**AUSTRALIAN
ZIRCONIA LTD**

**A Summary of
Minor Modifications**
to the
Proposed Operations
and/or
**Environmental
Assessment**
of the
Dubbo Zirconia Project

R.W. CORKERY & CO. PTY. LIMITED

April 2014

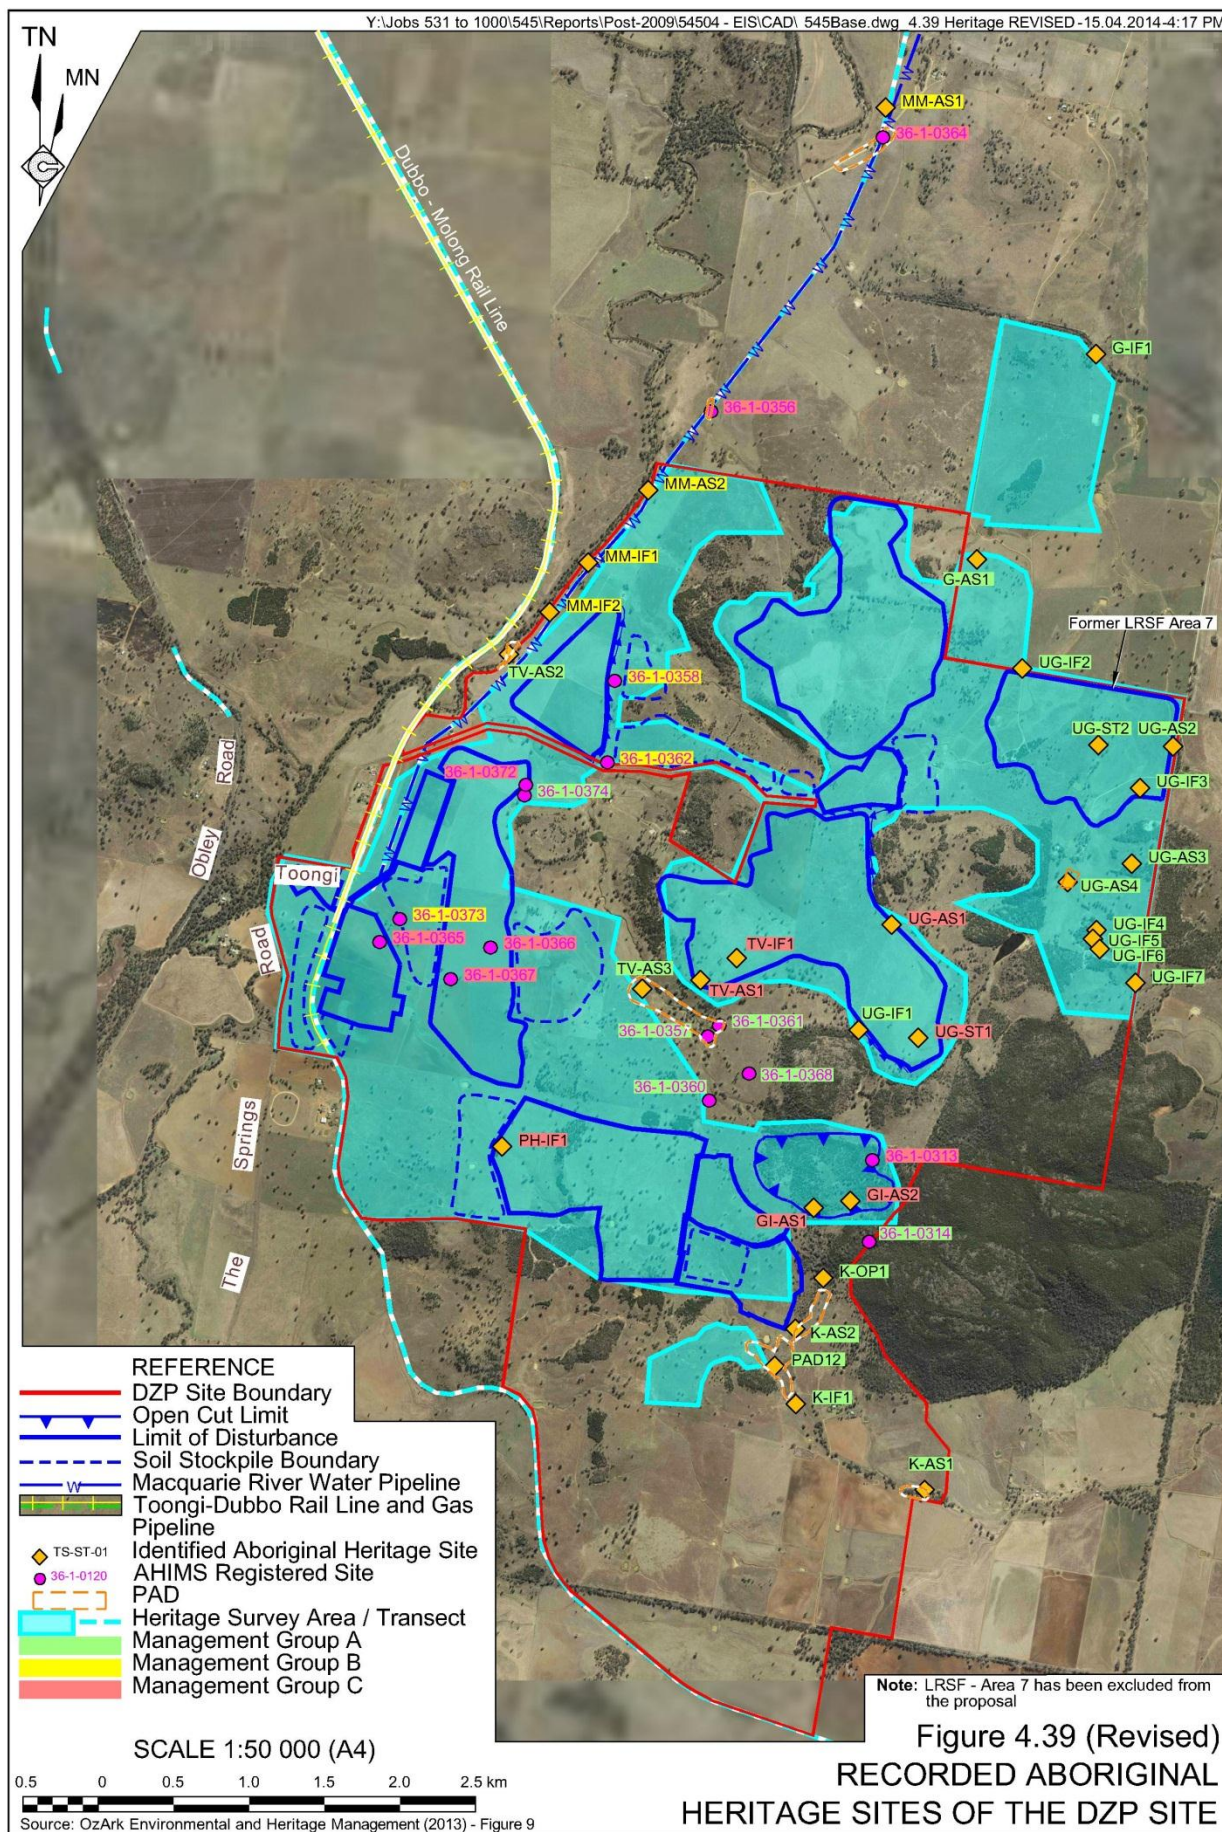
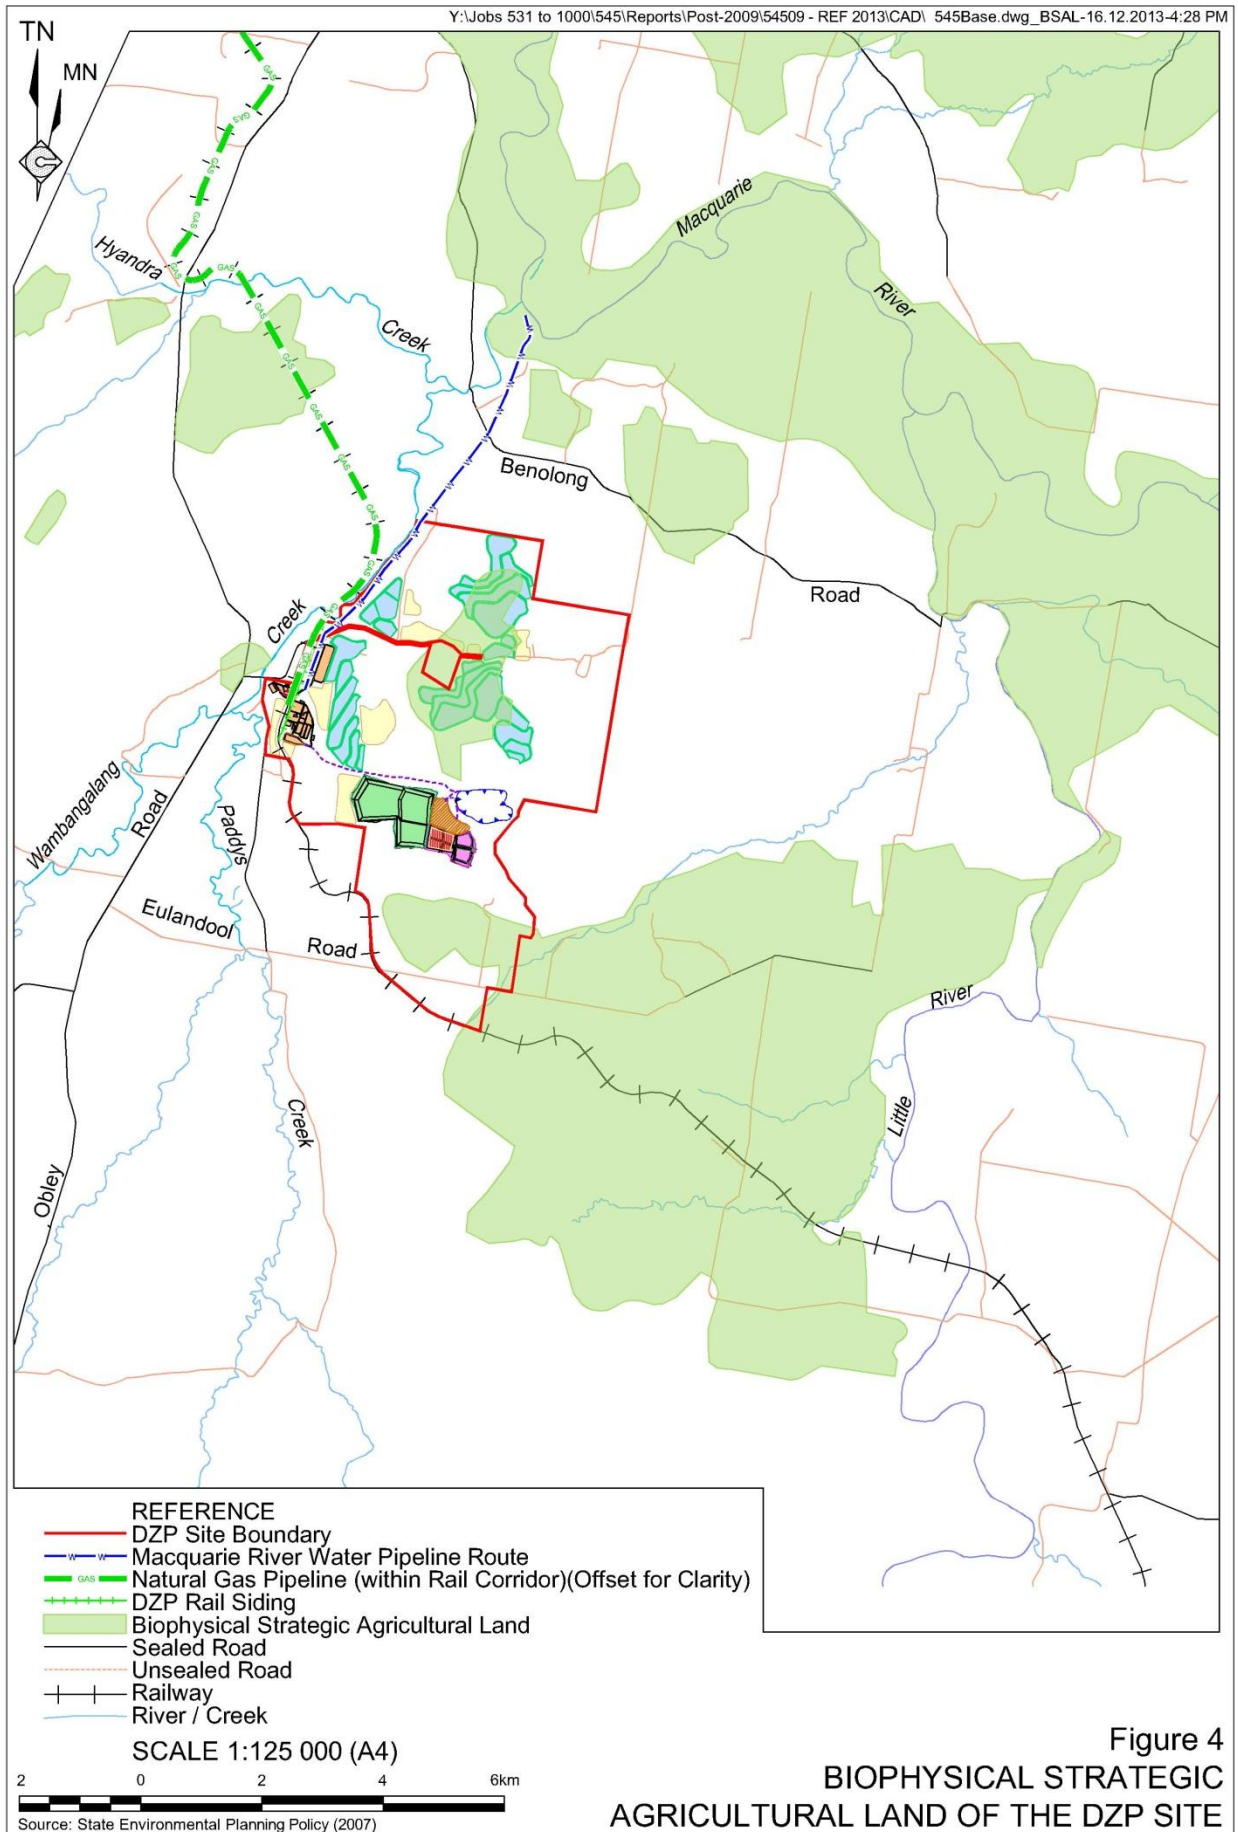
Figure 4.39 of the EIS incorrectly identifies Site GI-ST1 on the DZP Site. This site, along with PH-ST1, PH-ST2, TV-ST1 and TV-ST2 were classified originally as scarred trees, however, on review this classification was revised. **Figure 4.39 (Revised)** provides an accurate presentation of the identified Aboriginal Sites of the DZP Site.

While verification of BSAL on the DZP Site is not required on the basis of the above, **Figure 4** of the RTS (reproduced below) provides an illustration of the BSAL mapped over the DZP Site Layout by Strategic Agricultural Land Map – Sheet STA_022 (DP&I, 2013).

Figure 4 suggests that 148ha of LRSF Areas 4 and 5 occur on land identified as BSAL by the mapping currently on exhibition. A desktop review of the potential BSAL on the DZP Site undertaken by SSM, and their knowledge gained through on site investigations suggests that this BSAL mapping likely overstates the BSAL of the DZP Site. BSAL is more likely to be confined to the flatter land adjoining Wambangalang Creek.
